Determination 2017/029

Regarding the refusal to grant an amendment to a building consent and issue a code compliance certificate for a 16-year-old house with plywood cladding at 433 Pukehina Parade, Te Puke

Figure 2: Locations of proposed repairs (not to scale)

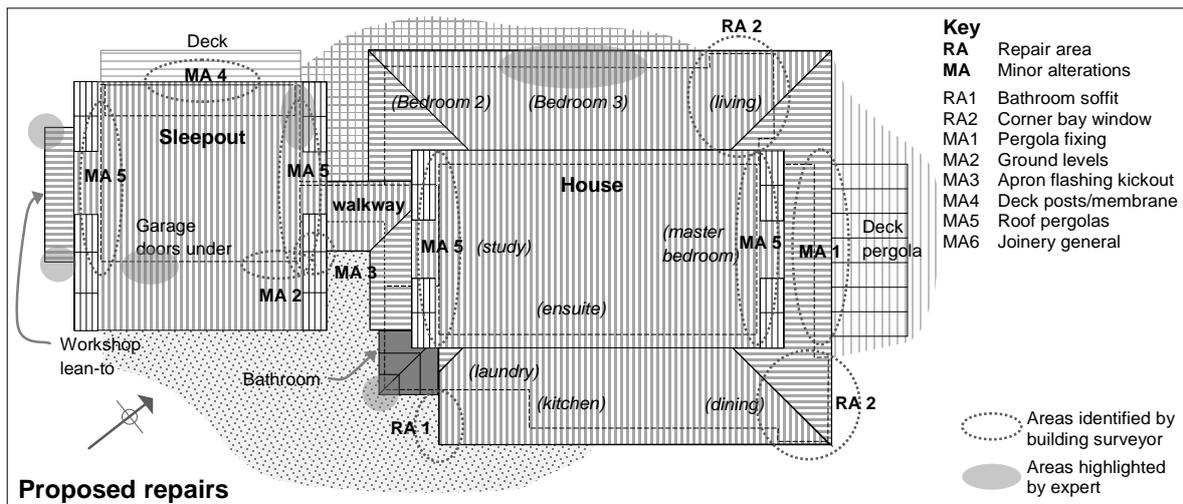
| Areas of repair (see Figure 2) | | Expert's comments | Expert's conclusion |
|-----------------------------------|---|--|--|
| RA1 | Laundry soffit framing | <ul style="list-style-type: none"> Lower plywood proud of upper Framing to clad end of soffit decayed No visible sign of damage to lower walls, but framing needs to be exposed to check | Scope of proposed repair sufficient to address defect, but further investigation of the framing below the bulkhead is required to check for damage |
| RA2 | Corner bay windows | <ul style="list-style-type: none"> Cladding removed to expose framing Framing below north window decayed Framing below east window stained No metal flashing under corner cladding Battens were in poor condition, with tops exposed to rain penetration Sill flashing detail still exposes batten tops (I also note battens lack weathergrooves) | Proposed details insufficient Further bay window and corner details required |
| MA1 | Pergola to NE deck | <ul style="list-style-type: none"> Pergola plate now spaced off cladding | Satisfactory |
| MA2 | Ground levels to east corner of garage | <ul style="list-style-type: none"> Some plywood sheets replaced Sheets fixed hard against concrete slab edge Framing condition not verified Clearances still limited Not in accord with proposed details | Further areas need attention Current repair not satisfactory Scope of proposed repair work is not sufficient to address the defect |
| MA3 | Kick-out to walkway apron flashing | <ul style="list-style-type: none"> End of apron flashing underlaps plywood horizontal flashing | Scope of proposed repair sufficient to address defect |
| MA4 | Membrane to sleepout deck | <ul style="list-style-type: none"> Membrane in good condition except for turn-ups at post penetrations | Scope of proposed repair sufficient to address defect |
| MA5 | Saddle flashings to roof pergola penetrations | <ul style="list-style-type: none"> Exposed ends of beams weathered Some flashings already installed Proposed work allows for investigation of underlying flashing and framing No visual evidence of failure | Scope of proposed repair sufficient to address defect |
| MA6 | Renew joinery jamb sealants, install new jamb battens | <ul style="list-style-type: none"> Timber jamb and sill battens with weathergrooves installed to some windows Sill flashings not installed Sill batten with flat top hard against sill flange Moisture readings to sill low | Proposed details insufficient: Specification, Sill details, Identification of windows to be repaired |

- 6.3.4 In considering the proposed remedial work provided, and taking into account the expert's comments, I am of the view that the repairs proposed (in the drawings dated 3 August 2016) are not adequate to ensure that the repaired building will comply with Clauses B1 Structure, B2 Durability and E2 External moisture.

- 6.3.5 I consider that final decisions on whether compliance can best be achieved by either remediation or re-cladding, or a combination of both, can only be made after further investigation of the cladding and underlying timber framing. This will require careful analysis by an appropriately qualified expert, and should include an investigation of the condition of the underlying framing. Once that decision is made, the chosen remedial option should be submitted to the authority for its approval.
